Title: **Stage 1 Road Safety Audit**

**Link Road to Clonlara Road, Baldonnell Business Park,
Dublin 22.**

Client: **PUNCH Consulting Engineers**

Report reference: **1462R01**

Drawing 212126-PUN-XX-XX-M2-C-0420 P03

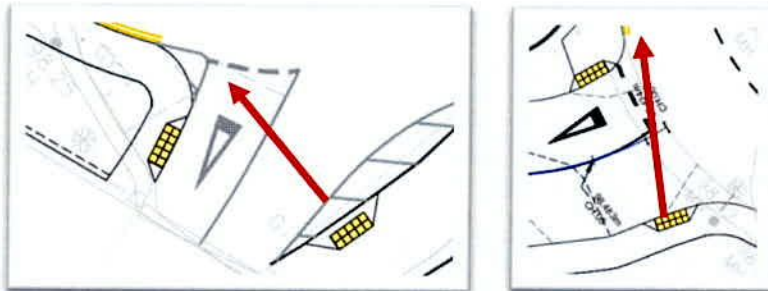
The tactile paving at the uncontrolled crossings do not align on either side of the carriageways. This could lead to blind or partially sighted pedestrians being directed incorrectly as they attempt to cross the carriageway. This could lead to collisions with passing vehicles.

It is recommended that the tactile paving be aligned.

Drawing 212126-PUN-XX-XX-M2-C-0420 P03

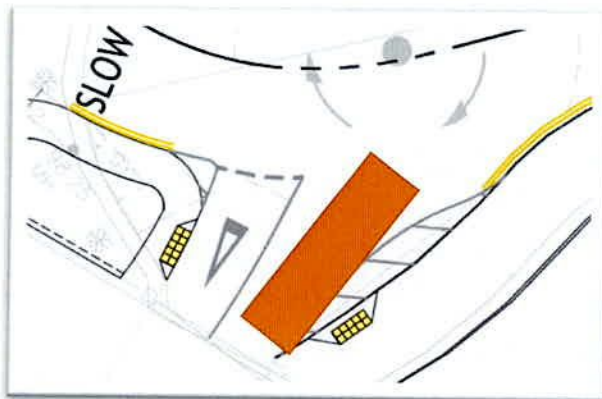
It is unclear if a HGV can park outside the Caulfield Transport gated entrance without overhanging the through road. If the trailer overhangs this could lead to side-swipe or rear-end collisions.

It is recommended that the gate be far enough back so that a HGV driver can pull clear of the carriageway when looking to speak through the intercom to gain access.
